### क्षतिग्रस्त ट्रांसमिशन लाइन टॉवरों पर विशेषज्ञों की स्थायी समिति की रिपोर्ट

REPORT OF THE STANDING COMMITTEE OF EXPERTS ON FAILURE OF EHV TRANSMISSION LINE TOWERS (APRIL 2019 – DECEMBER 2021)

भारत सरकार Government of India केन्द्रीय विद्युत प्राधिकरण Central Electricity Authority

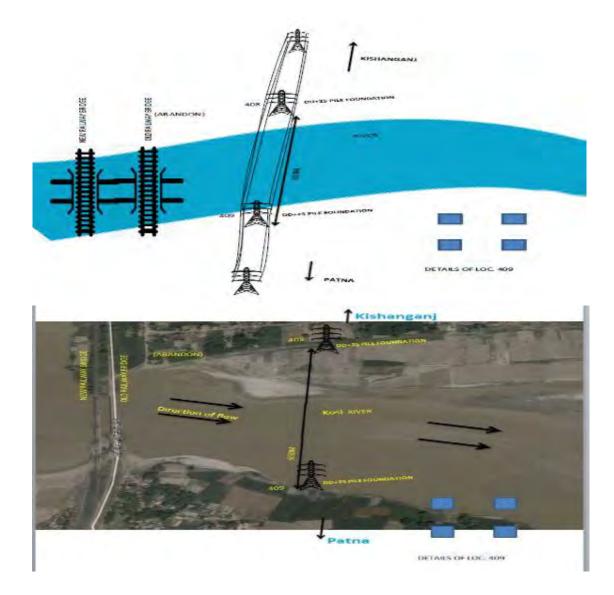
Committee noted that the transmission line had failed earlier in the years 2016 & 2018 due to similar cause of change of river course of River Ganga. Committee also observed that at the time of construction of line, the location 409 was on the right bank of River Kosi, and the river course is changing towards right bank. The erosion of bank had got extended up to the tower location and two legs on pile foundation which has led to failure and subsequent collapse of the tower have now come in the main stream.

Committee recommended that proper anticipation of change in course of river on the basis of river flow data of previous years should be done by the transmission utilities. Additional precautions like routing of transmission lines few kilometres away from the river bank/ anticipated future river course, use of pile foundation/additional piles etc. should be adopted by utilities. Moreover, in case of damage of foundation of towers, the foundation design is required to be examined.

First Stage Tower Strengthening Drawing

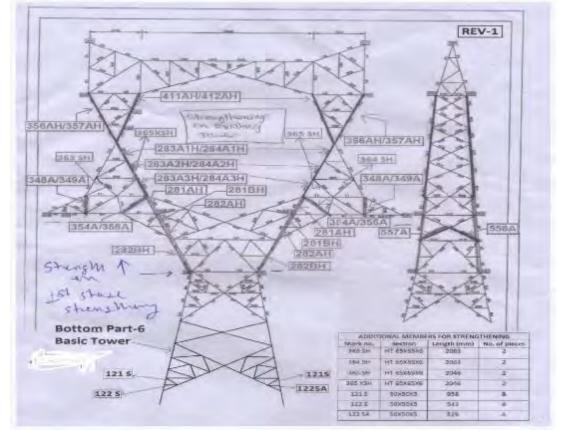
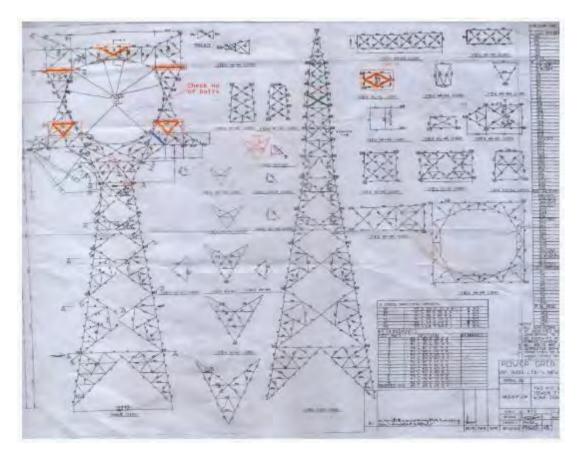
• The previous failures of the 765 kV S/C Delta configuration towers had been investigated by Standing Committee and the Committee had suggested strengthening of these towers. It was informed by POWERGRID that the failed towers were strengthened two times after commissioning. In the first stage additional members (shown as dark) for strengthening were provided as below:

• In the Second stage, tower strengthening of cross arms/peak members and redundant members was done at these failed location towers (as highlighted in attached drawing).

Committee further noted that the wind map of India has been revised and as per the latest wind map available in the National Building Code, 2016, the wind zone of the area in which the failed towers are located has been changed from Wind Zone 4 to Wind zone 5.

Sr. No.	Loc. No.	Tower Type	Span	Extent of Damage
1	388	DC+15		Intact

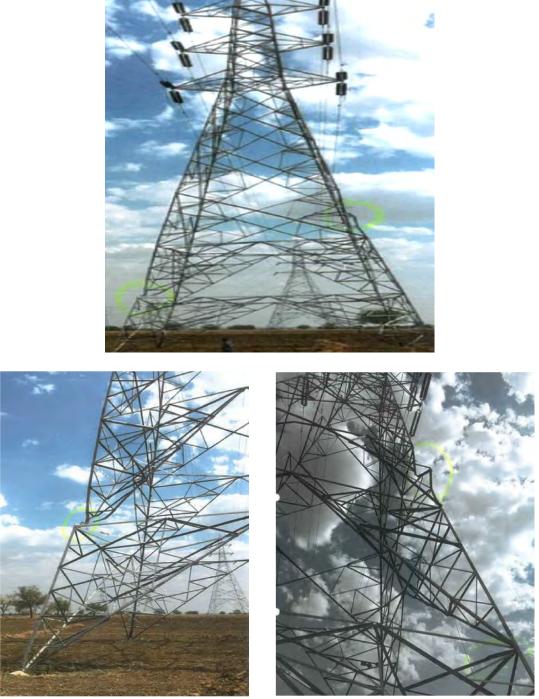
Committee noted that the towers were designed as per old IS codes, the narrow front wind factor and oblique wind load on tower structure would not have been considered in the design of towers and advised KPTCL to review the design of towers with respect to latest codes. Committee recommended that practices of using old designs of towers even after revision of IS codes should not be adopted by the utilities and all transmission towers should be checked on topmost priority after major wind event to remove fatigue and distortions, if any, so as to restore the original strength and avoid failures in subsequent event of high intensity winds.
